INDEPENDENT MONITOR AUDIT OF THE MCARTHUR RIVER MINE FOR THE 2011 OPERATIONAL PERIOD

ENVIRONMENTAL EARTH SCIENCES VIC
REPORT TO THE MINISTER FOR MINES AND ENERGY
1 OCTOBER 2012
VERSION 1

Figure 3 Relationship between dissolved Al and pH, DME EMU 2011 sampling (note logarithmic scale on y-axis)

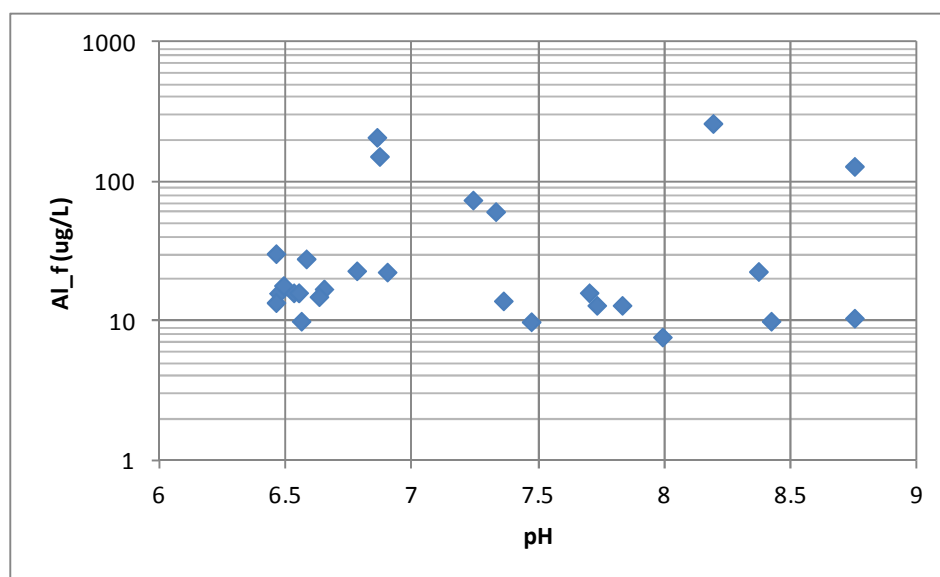
- dissolved Al results for the pH range measured strongly suggest an error with filtration of samples prior to acid preservation:
 - Al is insoluble in the pH range of 5.5-8.5, and as Figure 3 below demonstrates, this is not the case for the 2011 DME EMU data-set. Therefore sample collection, filtration and preservation practises for dissolved metals analysis require assessment and review;

Figure 4 Relationship between dissolved Al and turbidity, DME EMU 2011 sampling

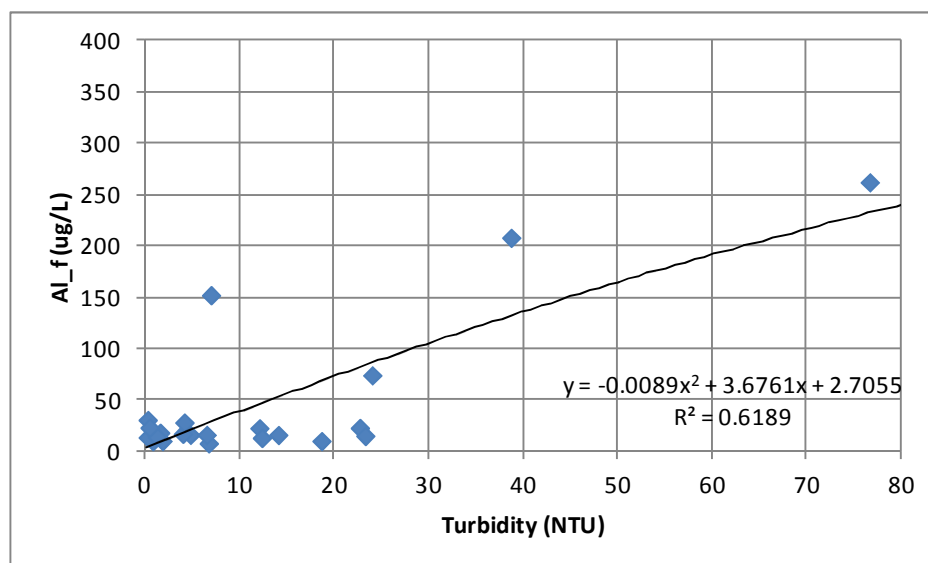
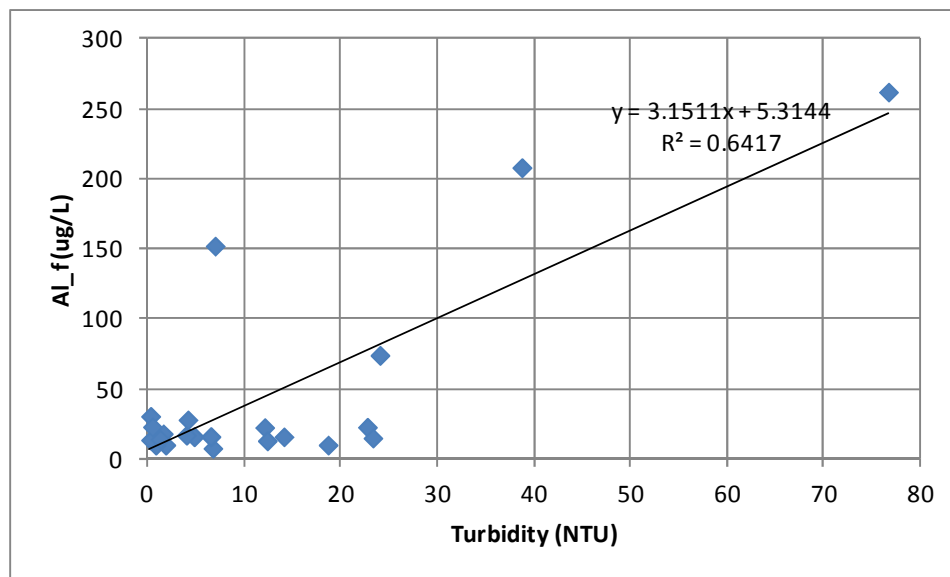
- it is considered likely that the problem relates to attempts to filter turbid samples, which seems to be supported by Figure 4 and Figure 5 below, which shows that a relationship exists between turbidity and dissolved Al. Hence, in addition to filtering in the laboratory (all the better if this is a mobile site laboratory), samples can be placed on a bench and the suspended sediment allowed to settle, then a sample of supernatant subsequently obtained from the top of the sample bottle for filtration; and

Figure 11 Chloride to sulfate ratios in groundwater in the vicinity of the OEF.

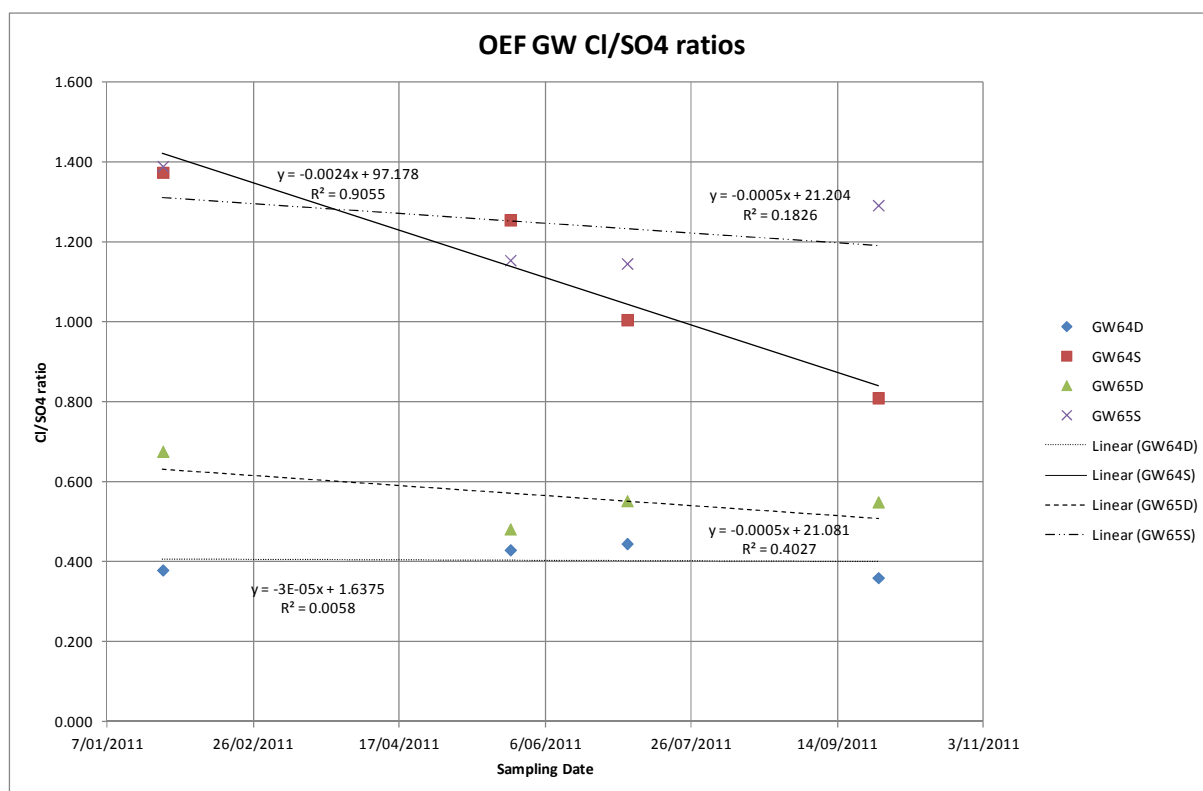
- the following comments are made on the analytical results observed for the 2011 monitoring period for bores about the OEF:
 - sulfate (SO₄) is elevated in GW64D and GW65D in particular, whilst the Cl/SO₄ ratio is also rapidly declining in GW64S (see Chart 1 below), suggesting that influences of neutral mine drainage may be apparent in these bores, with the relative influence of SO₄ on groundwater anion chemistry increasing over time (see Figure 11 below);

Figure 14 TIM levels in locations at locations within 1km from the PACRIM / ROM pad.
(Figure source: 2011/2012 MMP)

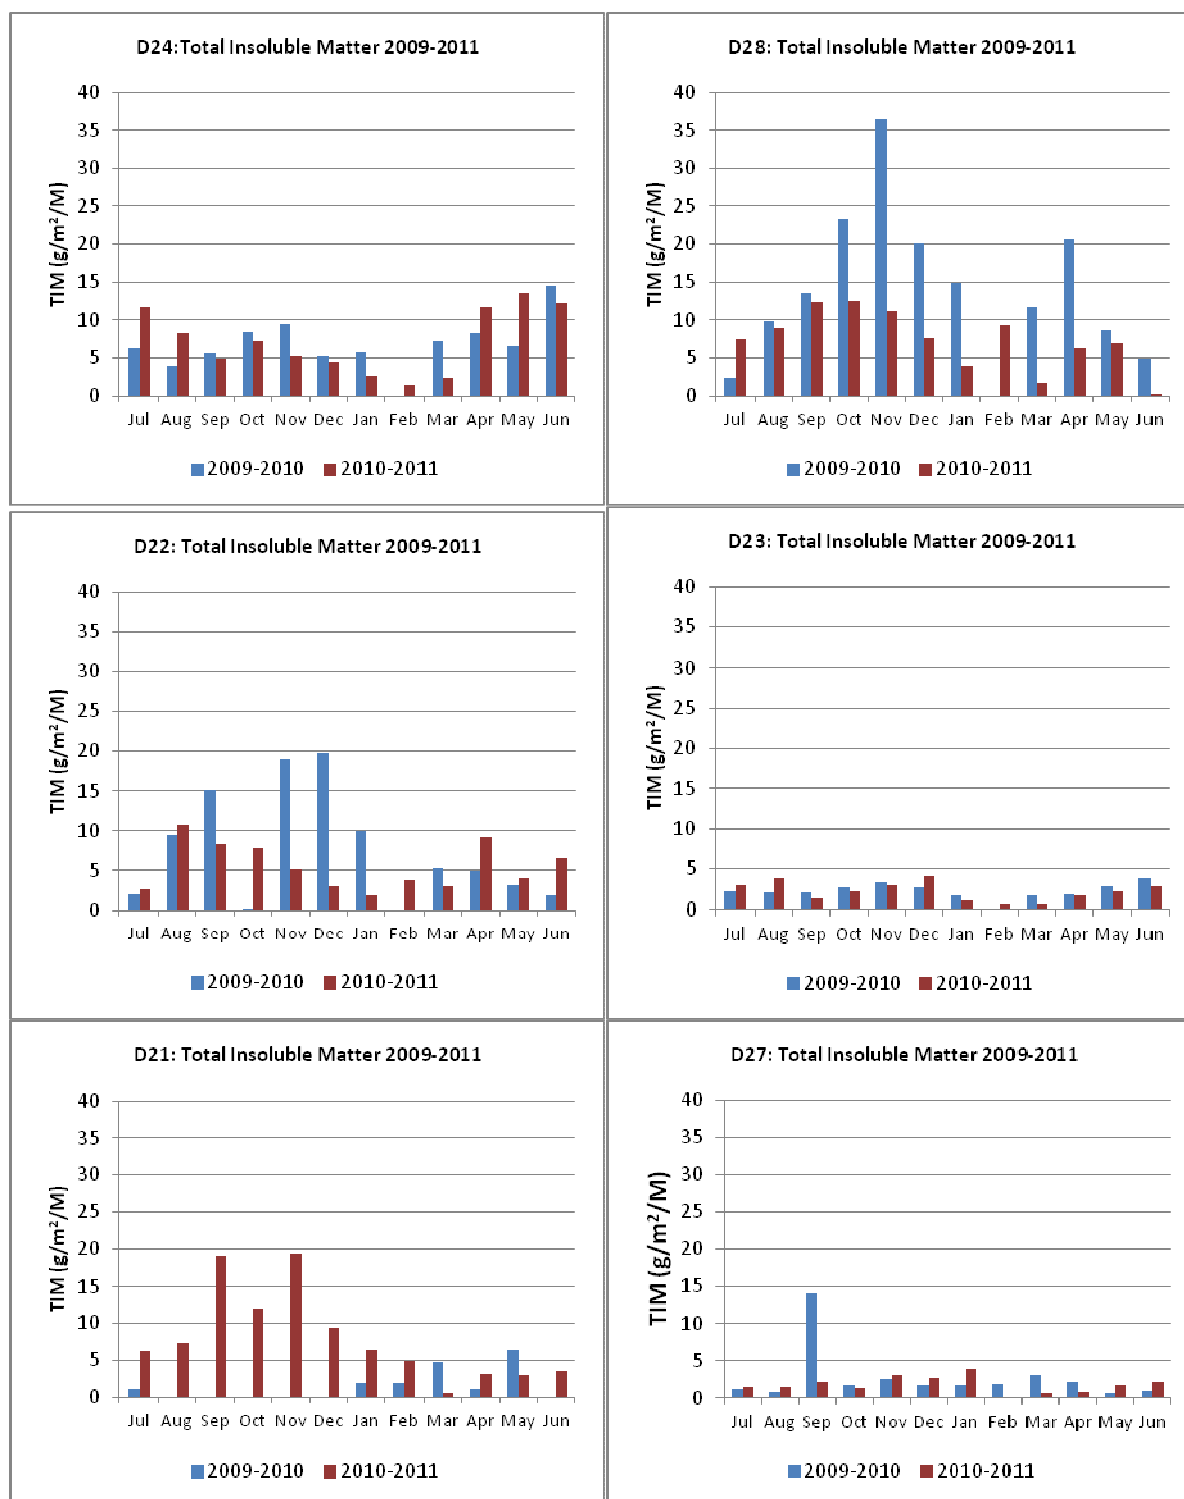
It is understood that MRM changed the analysis of total solids (TS) for TIM and that these parameters are not comparable; thus, only two years of data are presented in trend charts. The Independent Monitor however reiterates that the analysis of total Pb and Zn mass and concentrations has not changed thus these results could be presented in future MMPs particularly for problem areas (i.e. PACRIM and Bing-Bong). Figure 15 shows the TIM levels in locations at Bing Bong. Note the decrease in TIM levels since 2009.

Figure 31 Map showing location of topsoil stockpiling at the McArthur River mine. Topsoil is labelled as stockpiles and is represented by brown lines . (Figure sourced from 2011/2012 MMP)

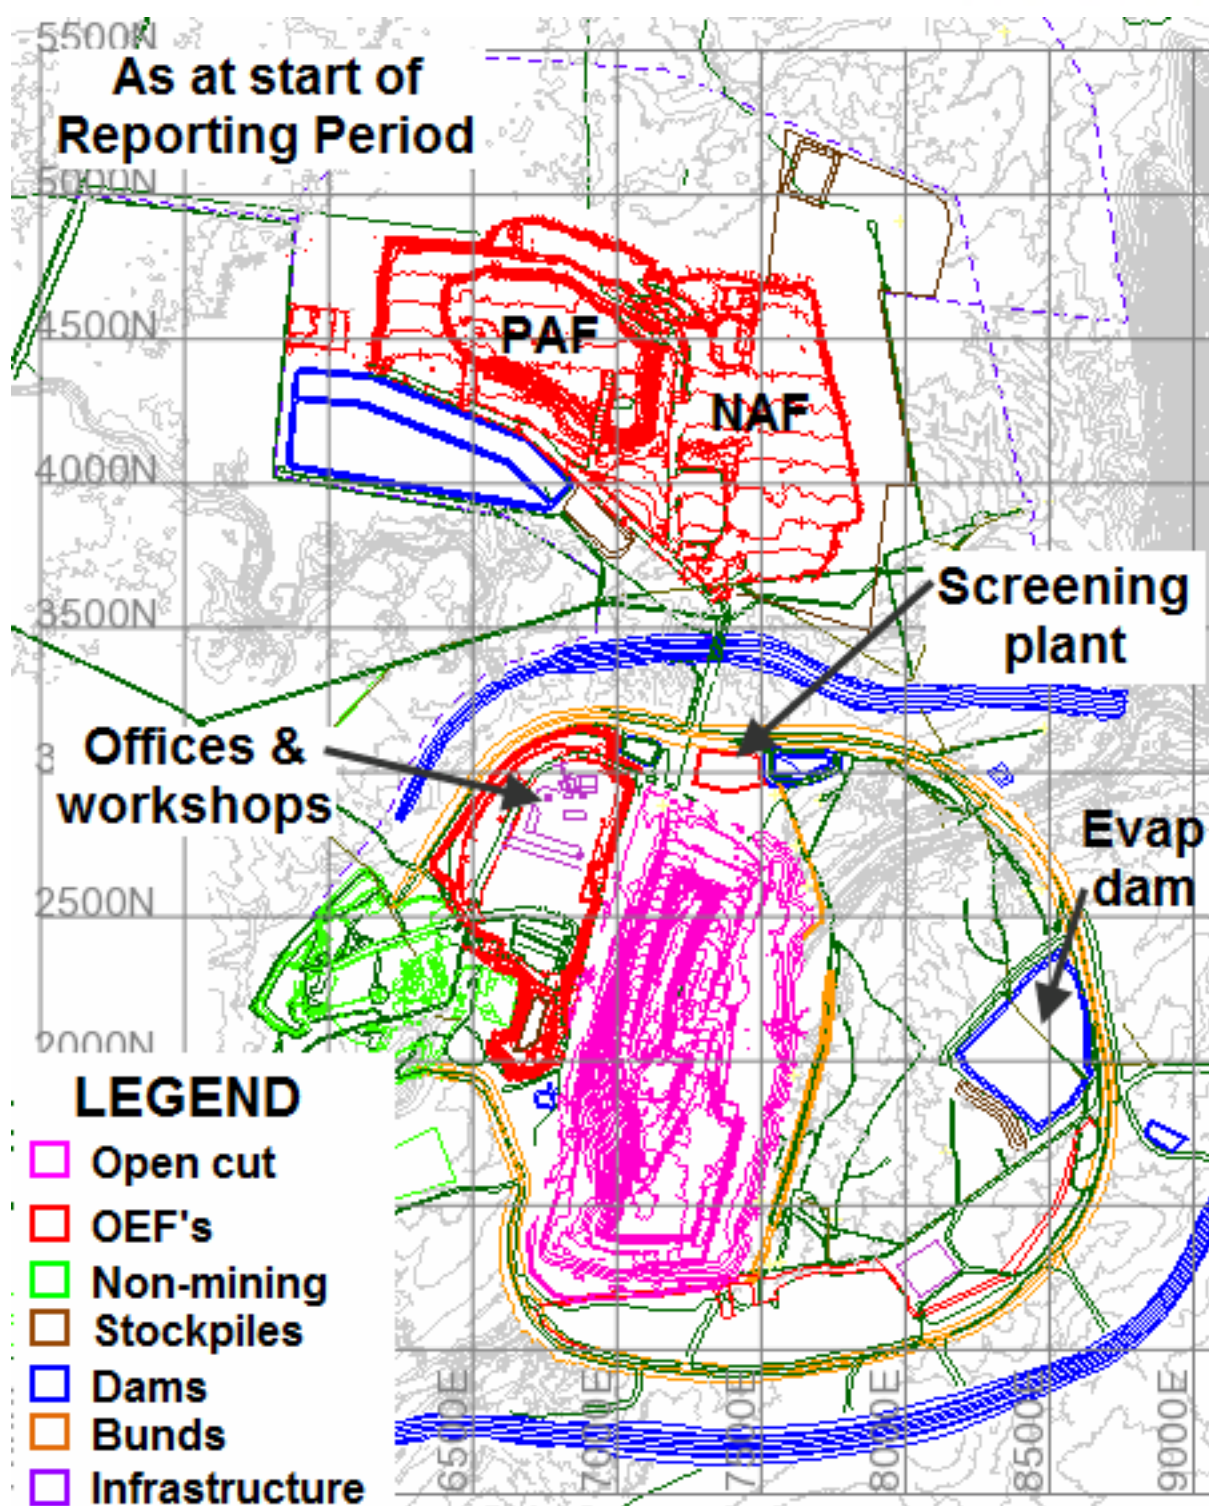
In the 2011/2012 MMP, MRM has included a topsoil management section. This section provides more information than seen in previous MMPs including information on where topsoil will be sourced from (section 4.1.7.7), where the topsoil will be stockpiled and where it is destined for (section 4.1.1.1), as per Independent Monitor recommendation (EES, 2011). Figure 4.1. in the 2011/2012 MMP illustrates the locations of topsoil stockpiling (Figure 31). Map should be improved as it is difficult to determine where topsoil stockpiles are located.

- expand information regarding rehabilitation in Table 3.1 in 2011/2012 MMP to include areas which will require rehabilitation in the future; and
- improve topsoil map to make it clearer where topsoil is stockpiled.

Plate 32 Aerial View of the Tailings Storage Facility, showing Cell1 (covered with a clay layer) to the left, and active Cell 2 to the right. May 2012.

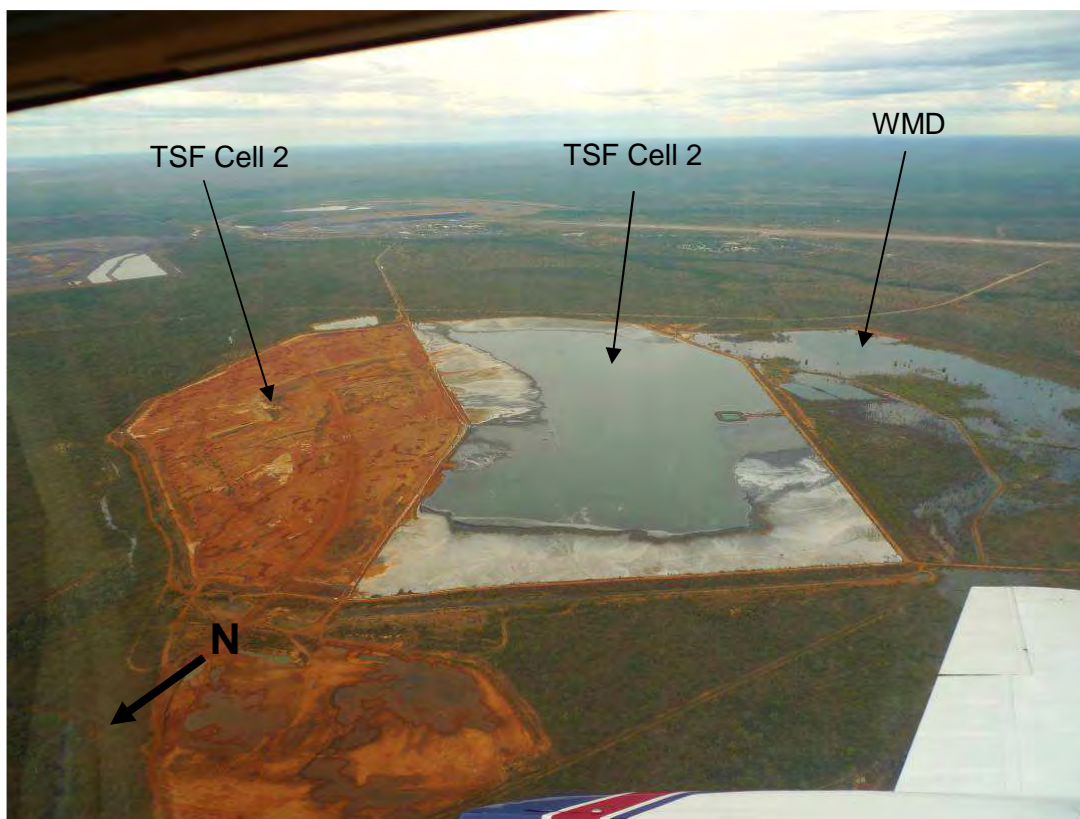
Within the 2010, 2011 and 2012 Independent Monitor audits, the Independent Monitor has expressed significant concern with a large supernatant pond formed within TSF Cell 2, (see Plate 32), which touches the southern TSF Cell 2 embankment for much of its length. The length of the embankment wall exposed to the pond has been reduced in 2012, and tailings was being deposited along the southern wall (see Plate 33) at the time of inspection. The following comment from the 2011 Audit report still stands this period:

Figure 34 Geochemical classification using NAPP/ NAG pH

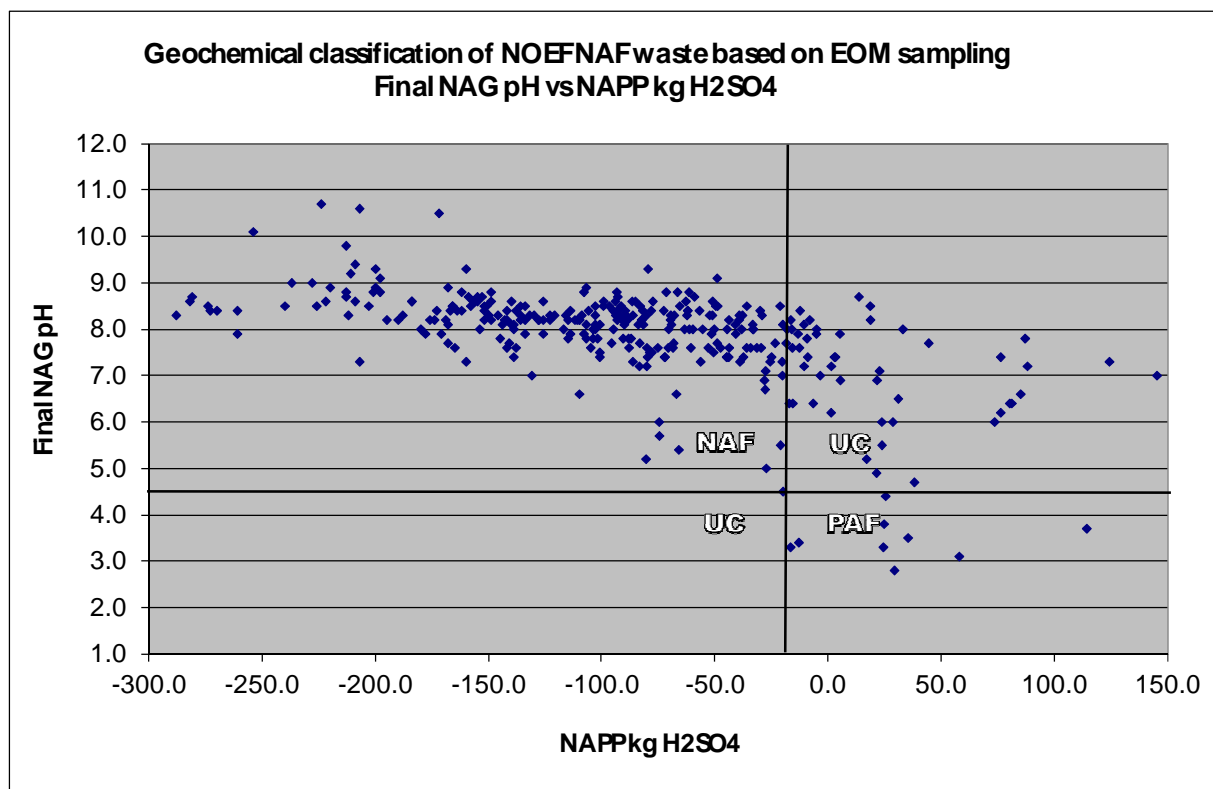
The data presented in Figure 34 indicates that only about 10 of a total of 330 samples analysed is classified as PAF based on NAPP/ NAG pH, however a large number of samples (>40) are classed as UC (uncertain) due to elevated NAPP. This is also illustrated in Figure 36, which shows that whilst all of the UC samples in Figure 34 have a NAG pH >4.5, total S is >2.5% (for >20 samples). Regardless of the NAPP classification (which is MPA – ANC), as the definition of PAF relates to the ratio of ANC and MPA the data presented in Figure 35 indicates that >10% of samples analysed are PAF (ANC/MPA <<2).

Figure 36 Geochemical classification using NAPP/ Total S%

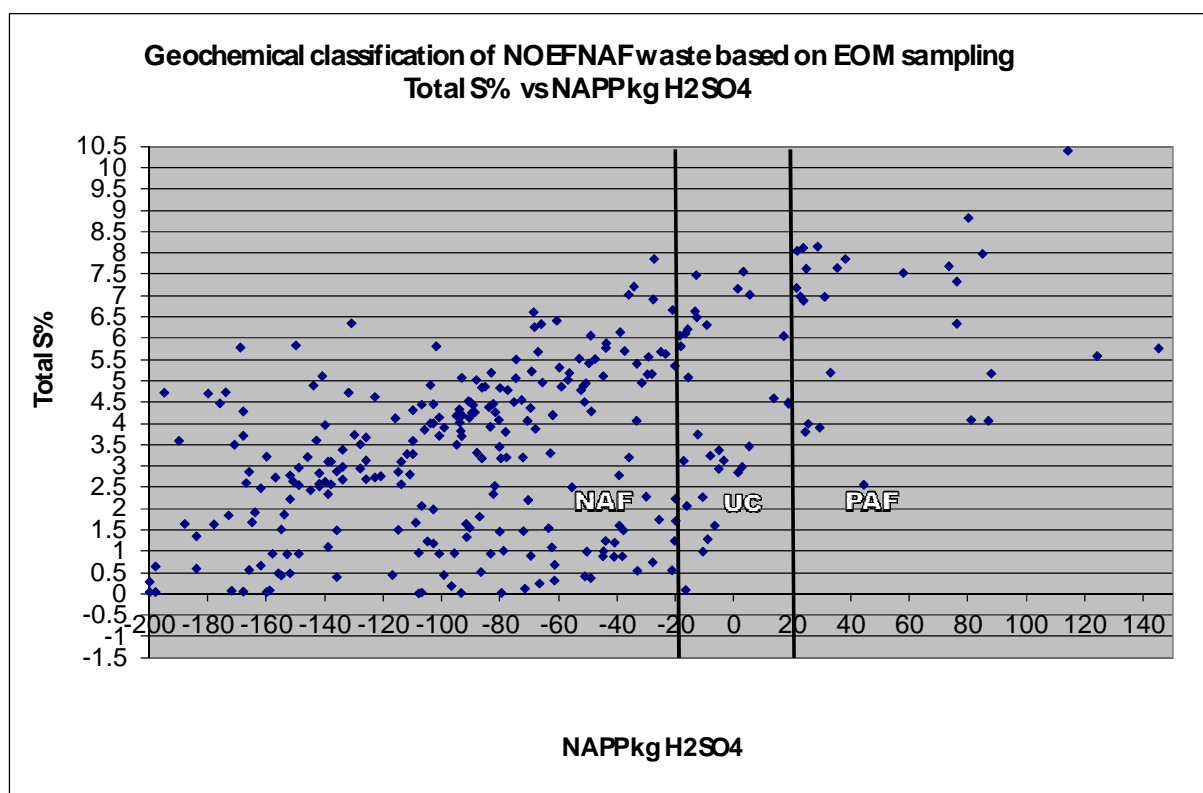
A review of the classification of NAF waste is required as the sulfur content is very high—often >5% total S (see Figure 36 above). This material generates a neutral pH leachate, but with high sulfate and metals caused by an acid drainage reaction. Due to the low solubility of the carbonates, the acidity from metal sulfide oxidation precedes the dissolution of the neutralising carbonate. There is also the potential for bypassing of the neutralising mineralogy if a difference of particle size or abundance occurs in the heap between acid generating sulfides and neutralising carbonate.
